Well Name: ZIA HILLS UNIT 2532 BS	Well Location: T26S / R32E / SEC 25 / NWNE / 32.011188 / -103.37382	County or Parish/State: LEA / NM
Well Number: 404H	Type of Well: OIL WELL	Allottee or Tribe Name:
Lease Number: NMLC069515	Unit or CA Name: BONE SPRING FORMATION PA "A"	Unit or CA Number: NMNM138329A
US Well Number: 300254336300X1	Operator: CONOCOPHILLIPS COMPANY

Type of Action: Plug and Abandonment

Proposed P&A NOI
ConocoPhillips Company
Zia Hills Unit 2532 BS #404H
30-025-43363

REVISED

ConocoPhillips		PROPOSED	
Author:	JJC	Well No.	404H
Well Name	Zia Hills Unit 2532 BS	API #:	30-025-43363
Field/Zone	Wildcat/Bone Spring	Location	349' FNL & 2310' FEL
County	Lea		Sec 25, T26S R32E
State	NM	GL/KB:	3133/
Spud Date	6/28/2018

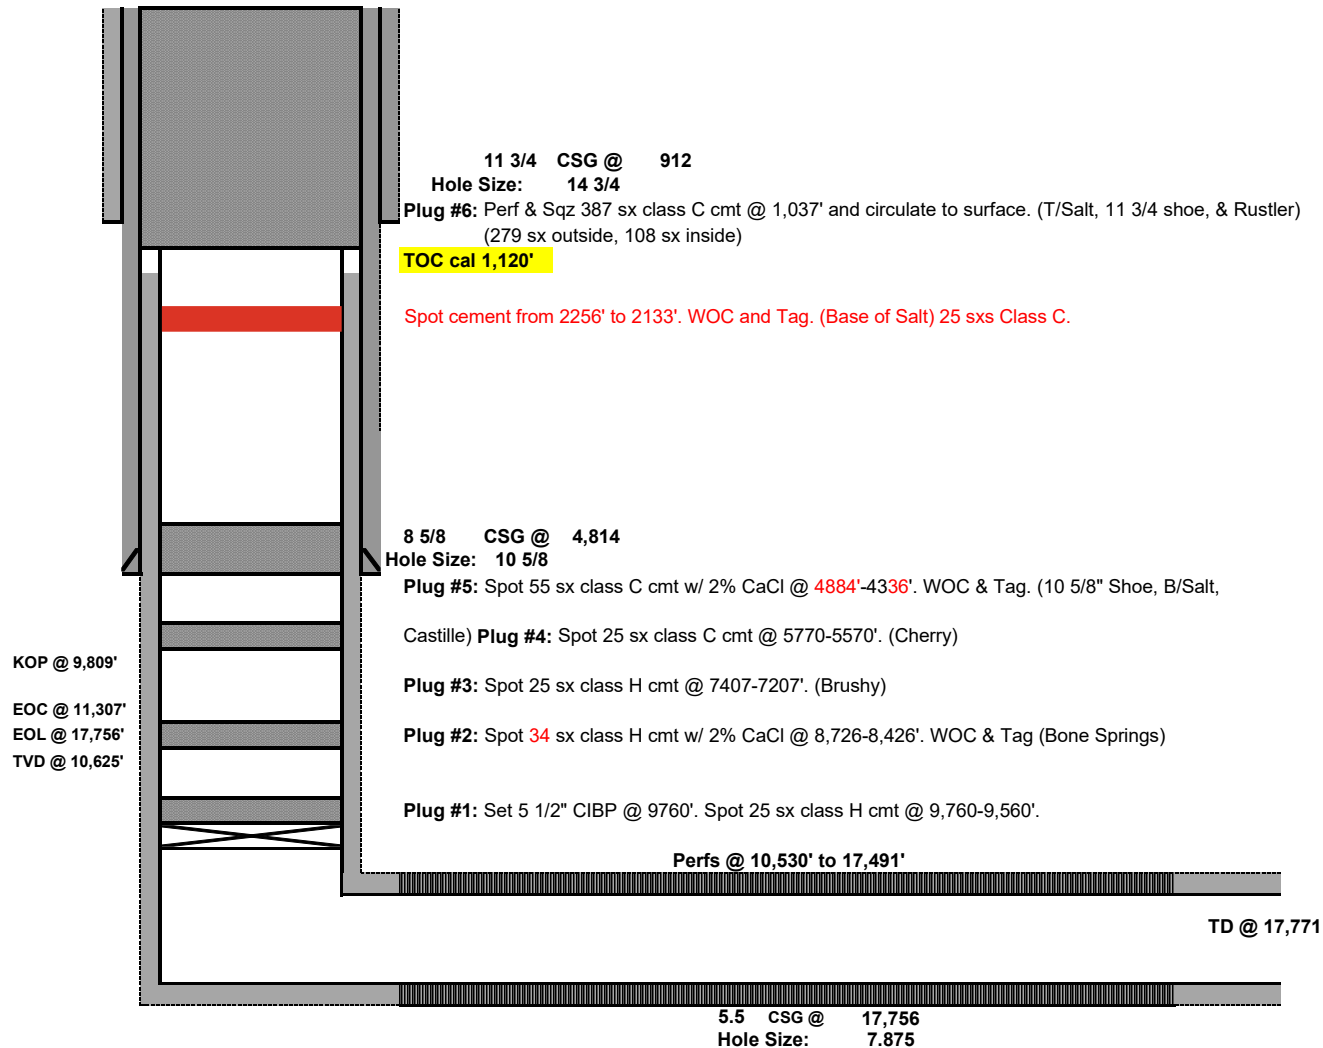
9. Plug 1: With CIBP @ 9,760', spot 25 sxs Class H cement from 9,760' to 9,560'.
10. Plug #2: Bone Springs formation: Spot 34 sxs Class H cement w/ 2% CACL from 8,726' to 8,426'. WOC & Tag. If tag is below 8,426', contact BLM & NMOCD representatives for procedure change.

13. Plug 5: 10 5/8" shoe, B/Salt, & Castille formation tops: Spot 55 sxs Class C cement w/ 2% CaCl from 4,884' to 4,336'. WOC & tag. If tag is below 4,336', contact BLM & NMOCD representatives for procedure change.

14. Plug 6: Spot cement from 2256' to 2133'. WOC and Tag. 25 sxs Class C.
15. Plug #7: T/Salt & Rustler formation tops, 9 5/8" Shoe & surface plug: Perf & Sqz 387 sx class C cement (279 sxs outside, 108 sxs inside) from 1,037' to 5' and circulate good cement out casing and annulus.

*Run CBL from CIBP to surface.

Submit results to BLM.
